# Quality Measures Non-compliance Report

Transpower New Zealand Limited's  
performance for the  
2016 and 2017 disclosure years

Stage 1 Report  
for  
The Commerce Commission

FINAL STAGE 1 REPORT  
12<sup>th</sup> August 2019

Figure 4: Energy lost due to N-security site interruptions in 2015-16

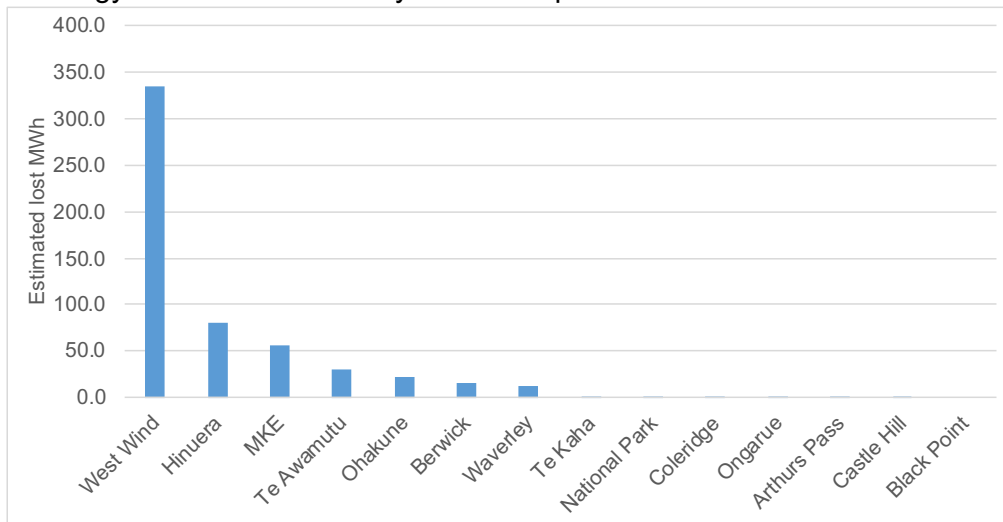
88. We do consider that the potential cost of interruptions is important to highlight. Figure 4 presents the estimated energy lost due to N-security interruptions by cause. It is possible, using wholesale market price differences for forgone generation and Value of Lost Load (VoLL) for supply lost to consumers, to establish a cost of interruptions. In our view, this would be valuable information to present alongside the current measures.

Figure 8: Duration of RCP2 HVAC Circuit Outages in 2015-16 by start date

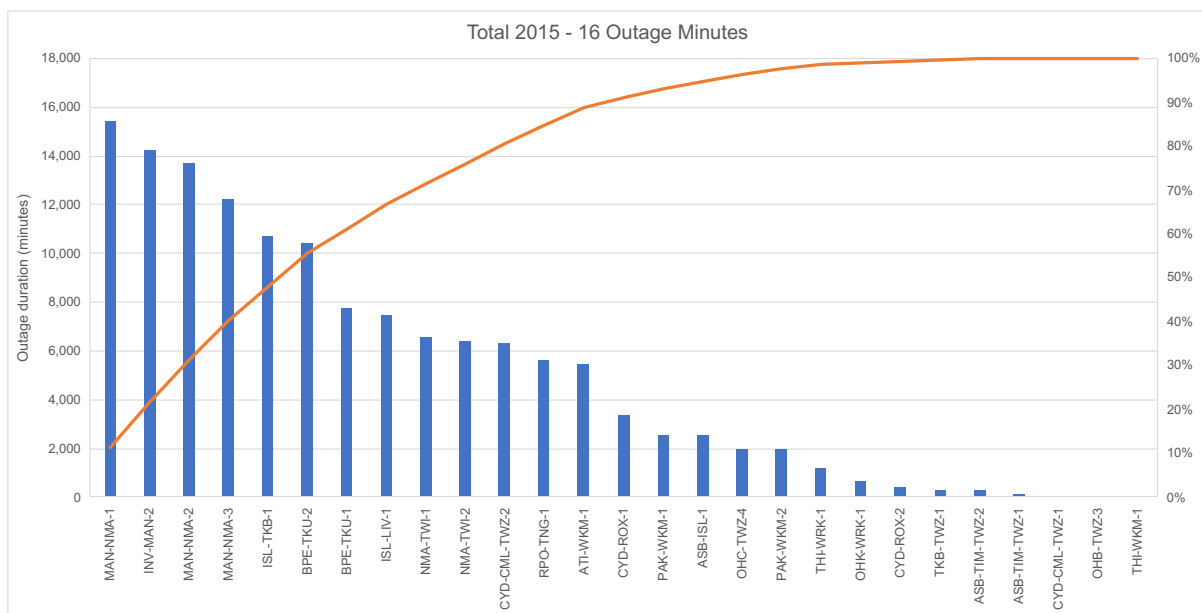
- 127. Planned outages on circuits in the lower South Island made the most significant contribution to outages and Transpower’s failure to perform within its cap for the 2015-16 availability measure (Figure 8).

- 129. The work undertaken on the four highest contributing circuits accounted for 35% of the total circuit outage duration which occurred between 5<sup>th</sup> October and 20 November 2015. Had these planned outages not occurred, circuit availability for the 2015-16 year would have been 99.42 which is within the cap and collar boundaries.

Figure 12: Work on the Invercargill-Manapouri Circuit 2 requiring circuit outages in 2016-17

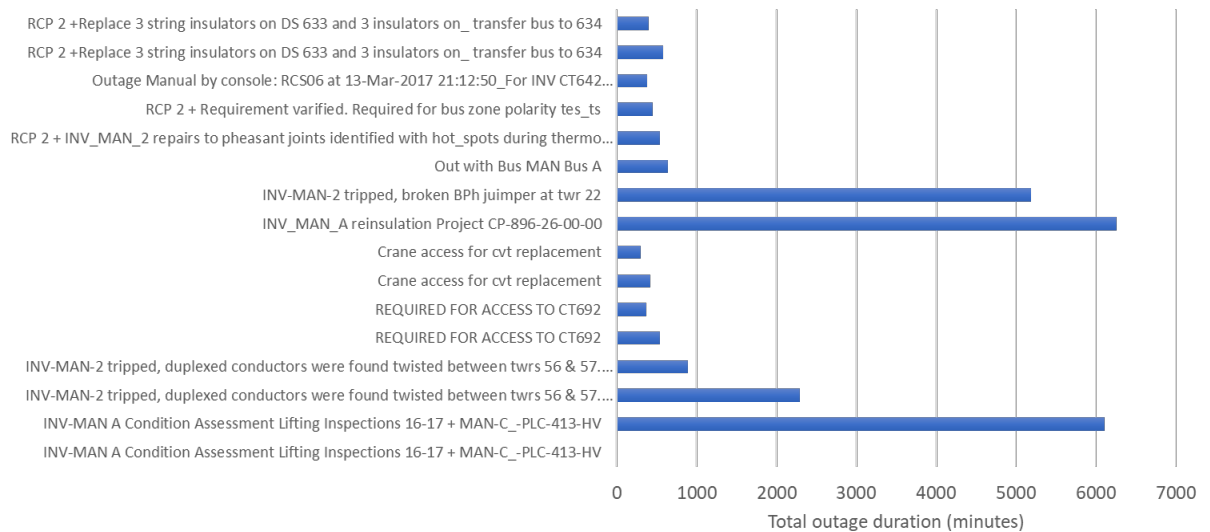
136. The planned work on the Invercargill-Manapouri Circuit 2 totalled 16,986 minutes. Figure 12 shows that this was dominated by two projects for condition assessment lifting inspections and reinsulation.

Figure 13: Comparison between the RCP2 target and total HVAC network historical availability performance

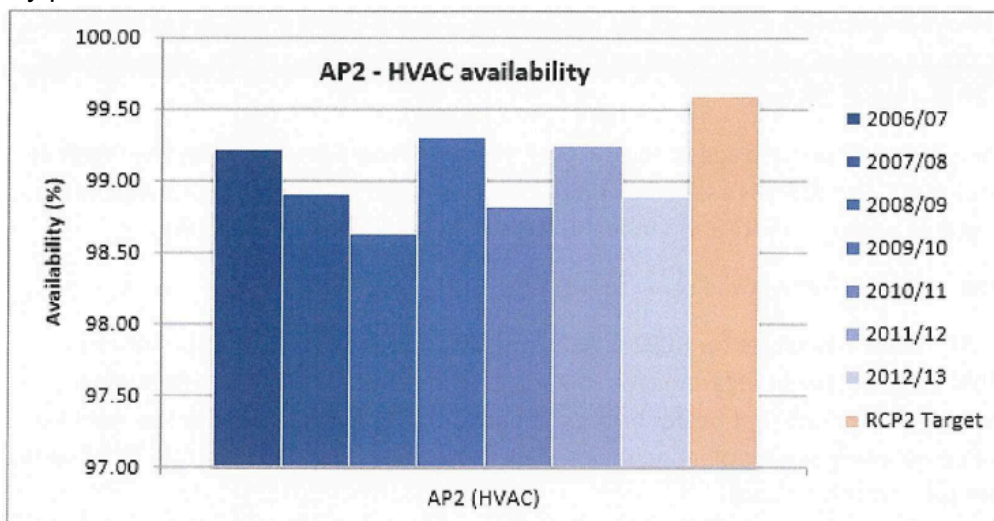
141. The average availability for the two years 2015-17 was higher than the average for the previous 7 years that preceded RCP2 (Figure 13). Transpower claims that this supports its view that the target and collar was set at an aspirational level.

Figure 14: Comparison between the RCP2 target and the 27 selected circuit historical availability performance

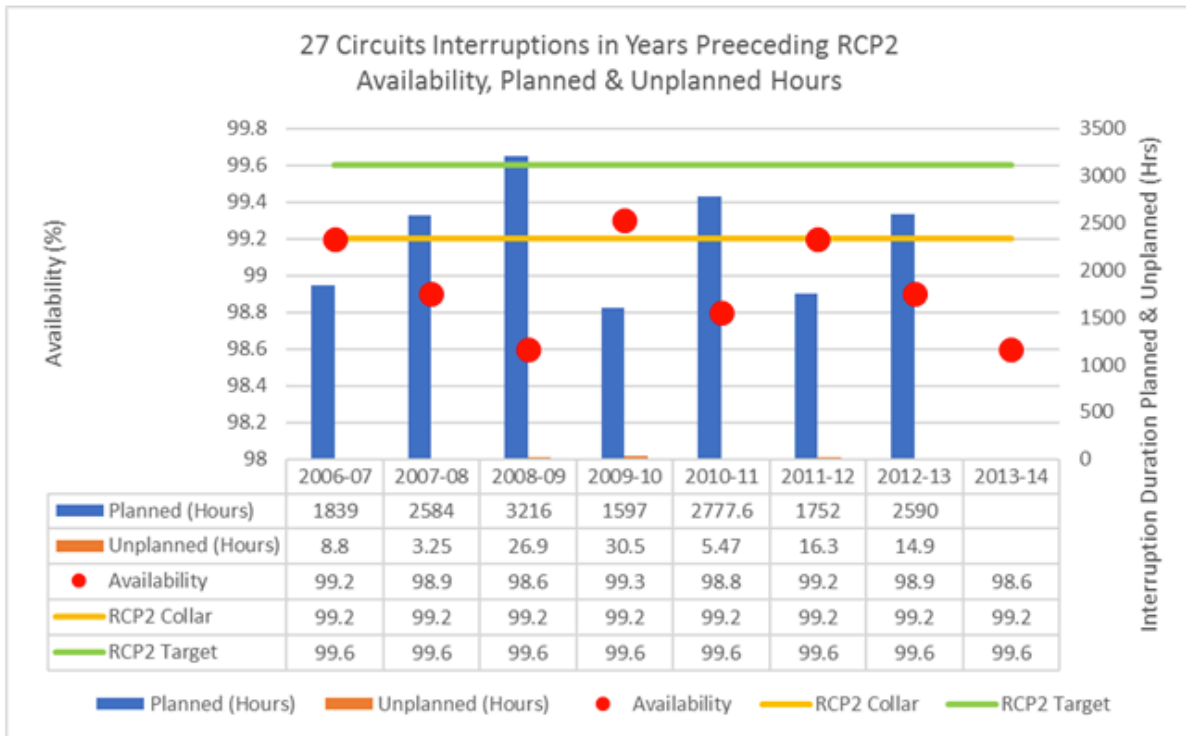
- 145. Transpower has not provided any analysis on the underlying factors relating to the historical years and explanation on why these factors were not taken into account when it proposed the RCP2 target, cap and collar.
- 146. The data supports the view that Transpower proposed a target and collar on the expectation that its RCP2 availability performance would be higher than it had historically achieved. The data does not explain why Transpower proposed a target and collar at these levels.

Figure 17: Duration trend for tower painting refurbishment

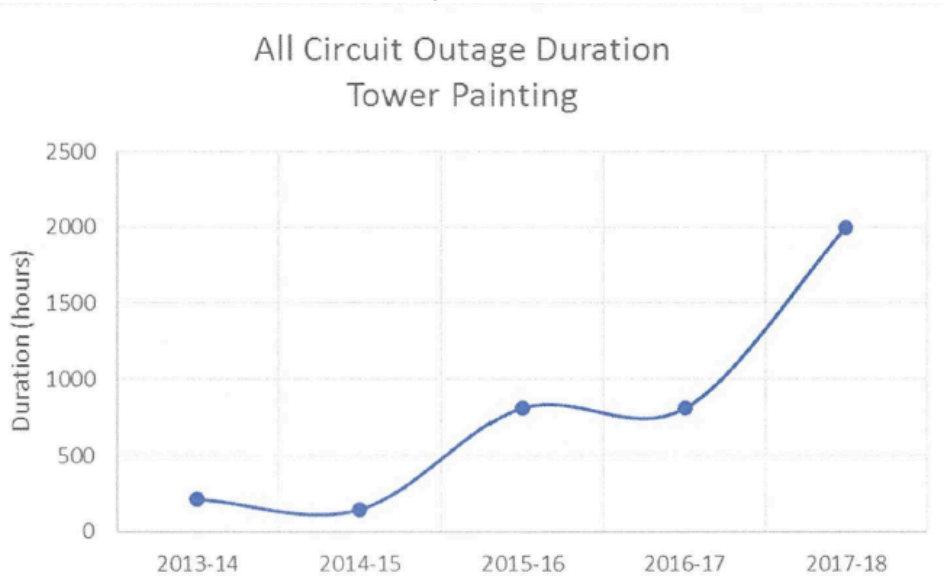
156. We understand that this target was formed on a largely bottom up basis that, without a rigorous top down review, may swing the target, cap and collar from being optimistic to pessimistic. For example, Transpower shows the impact of tower painting as an increasing trendline (Figure 17). Transpower attributes the trend to its suspension of live line work.

157. Transpower provided information that it is investigating alternative methods for tower painting that will allow live line painting. Key top down challenge questions are:
